# City of Florence

RE: AR 23 10 DR 01 – Starbucks Landscaping and Stormwater Management Plan

**PROJECT:** **AR 23 10 DR 01 – 1940 Hwy 101 Starbucks Landscape & Stormwater Management Review**

**Date of Report:** December 27, 2023      **Planner:** Clare Kurth  
**Application:** AR 23 10 DR 01  
**Related Files:** SR 23 41 DR 13, SR 23 42 DR 14, and SR 23 43 DR 15

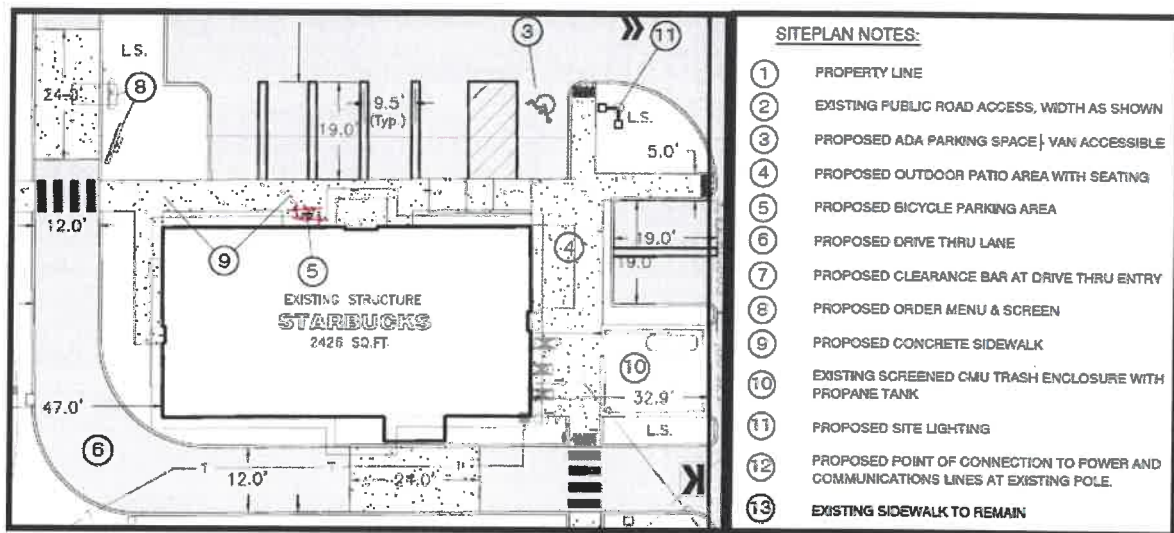
Locations of existing fences and walls were included on site plans submitted (Exhibit D). There is an existing CMU trash enclosure to the east of the building that screens the propane tank and is used as a trash enclosure (Sheet SP 01).

The landscaping plan (Sheet LS 01) includes compact English Laurels along the Hwy 101 frontage and Blue Oat Grass along the northern property line adjacent to the drive thru line, and Blue Oat Grass and Cherry Trees along the southern drive thru lane as screening materials.

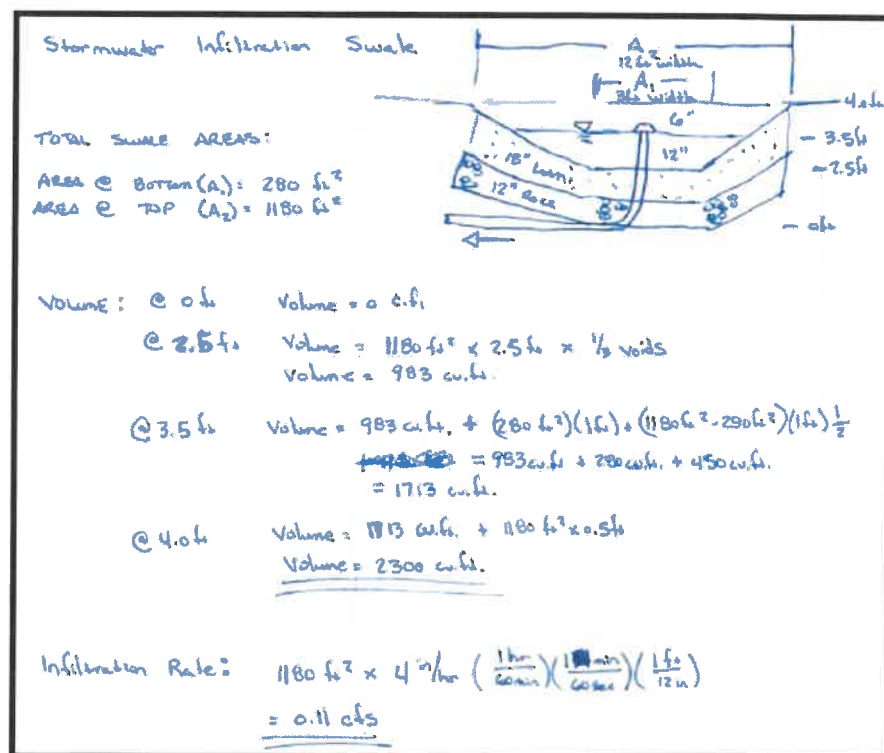
This application review is not reviewing hardscape features towards landscape requirements. The landscape plan exceeds minimum landscaping requirements.

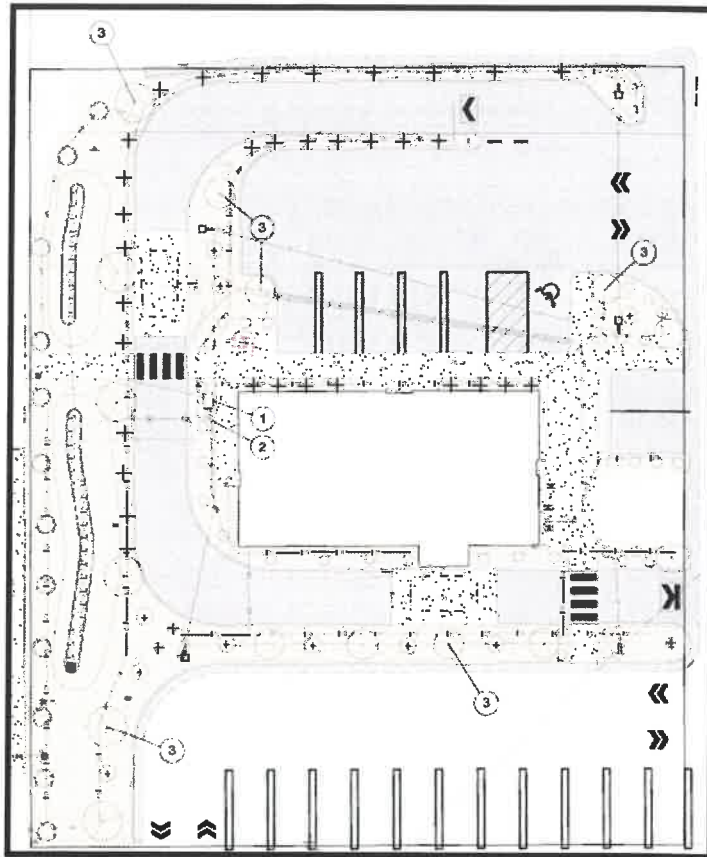
Changes to the layout of the site are proposed, but the building and majority of the landscaping areas are pre-existing. The site requires 19 parking spaces. Therefore, parking lot 'islands' are not required, but interior parking lot landscaping areas have been provided as seen in the landscaping plan provided on Sheet LS 01. This criterion is not applicable.

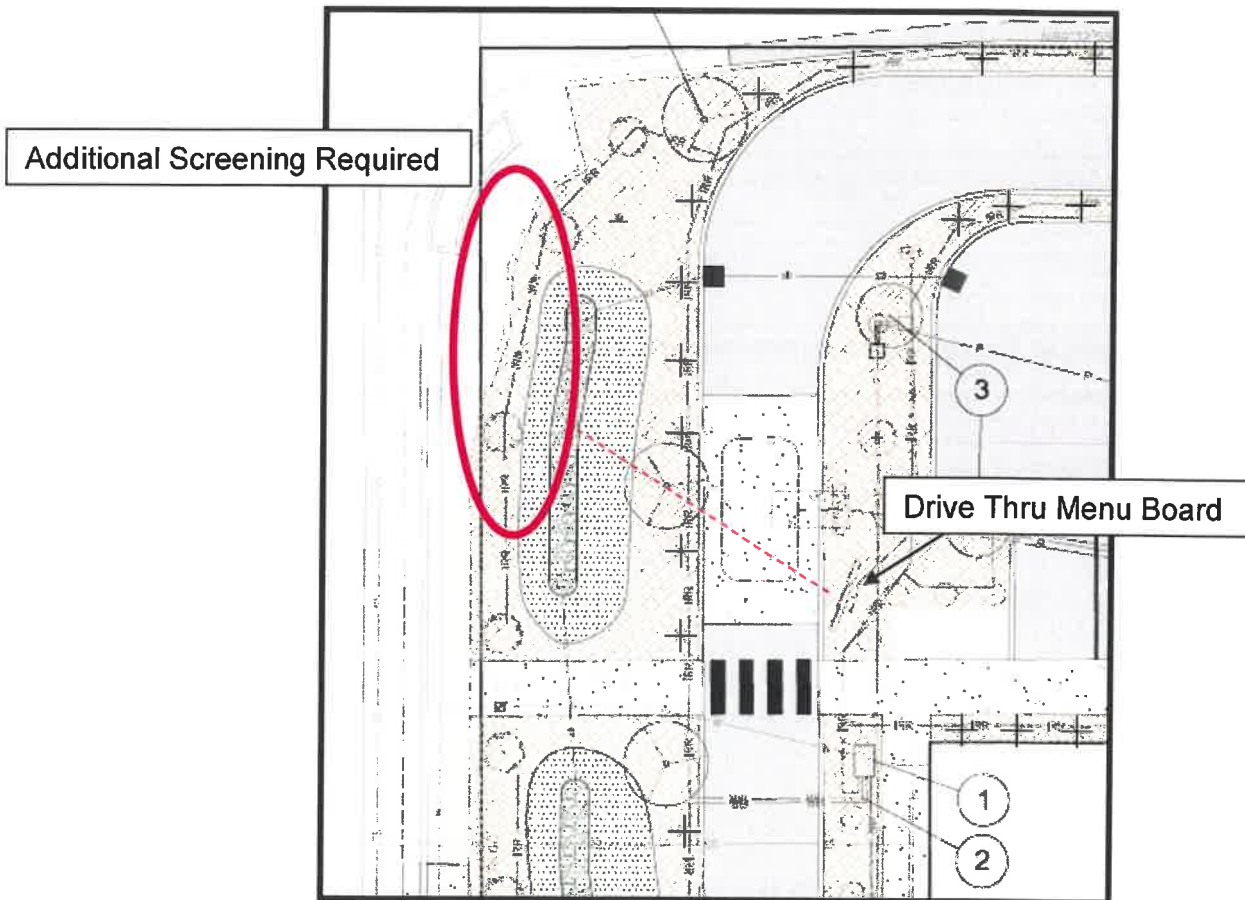
The parking and maneuvering areas adjacent to the building is separated by either a walk way not less than 5' in width and/or a curb that is 6" in height. This criterion is met.

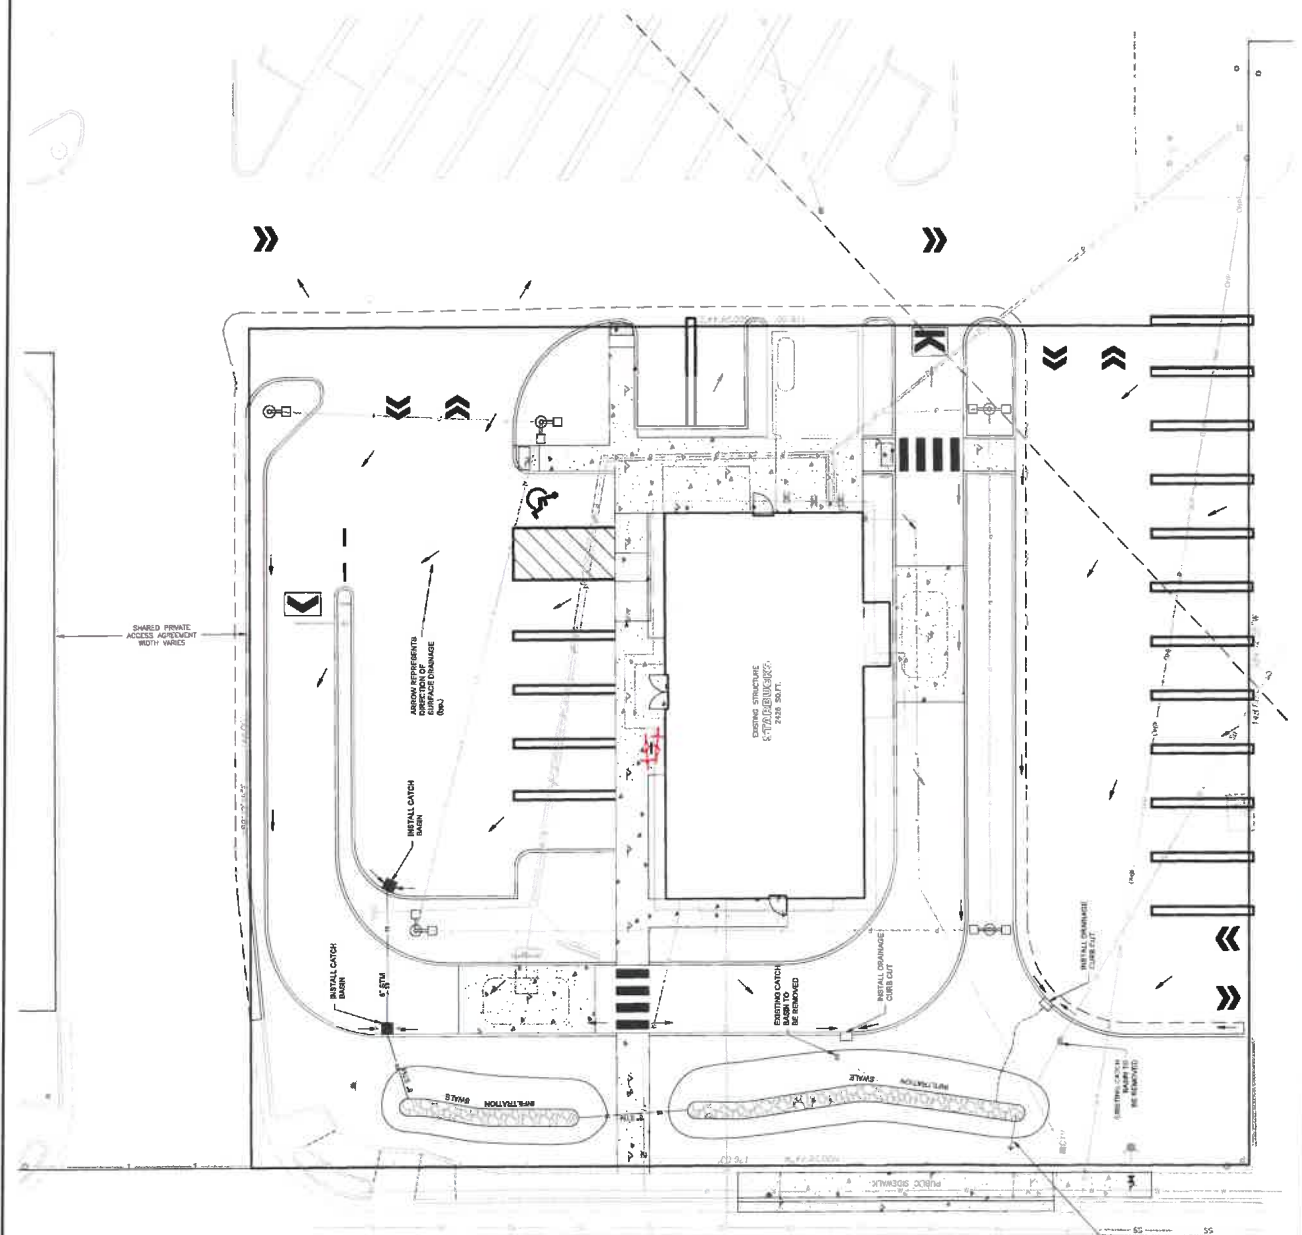
Overflow is addressed on Sheet SP 03, see snip below. In the last line of number 2 it states *“overflow discharging the the existing storm line that drains to US 101.”* This is likely a service line and is anticipated to be acceptable. This criterion is met.
